Subject: POPPING NOISE THROUGH SPEAKER WHEN OPERATING POWER WINDOWS	Bulletin No: 09-011/15
	Last Issued: 04/13/2015

2014-2015 Mazda3 (Japan built) vehicles (with BOSE audio) with VINS lower than JM1BM*****259081 (produced before February 2, 2015)

2014-2015 Mazda3 (Mexico built) vehicles (with BOSE audio) with VINS lower than 3MZBM*****182009 (produced before January 1, 2015)

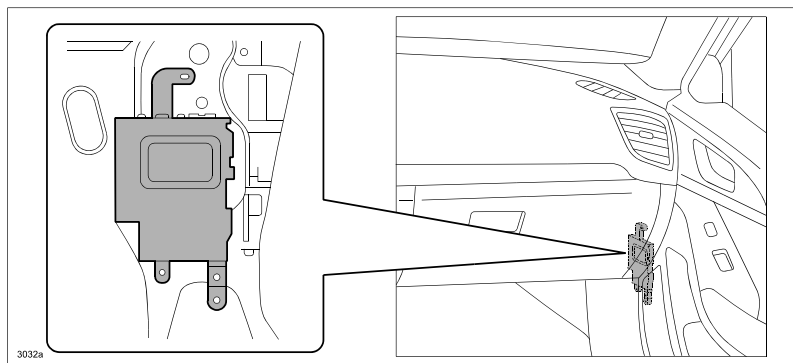
Some vehicles may experience a popping noise coming from the speaker(s) when operating the power window master switches at the driver's door. This is caused by insufficient noise suppression in the Tuner Amp Unit (TAU). To correct the problem, the internal noise suppressor in the TAU has been changed.

1. Verify customer concern.
2. Remove the TAU and replace with a modified one according to the instructions on MS3 online or the Workshop Manual (section 09-20 TUNER AND AMP UNIT (TAU) REMOVAL/INSTALLATION).
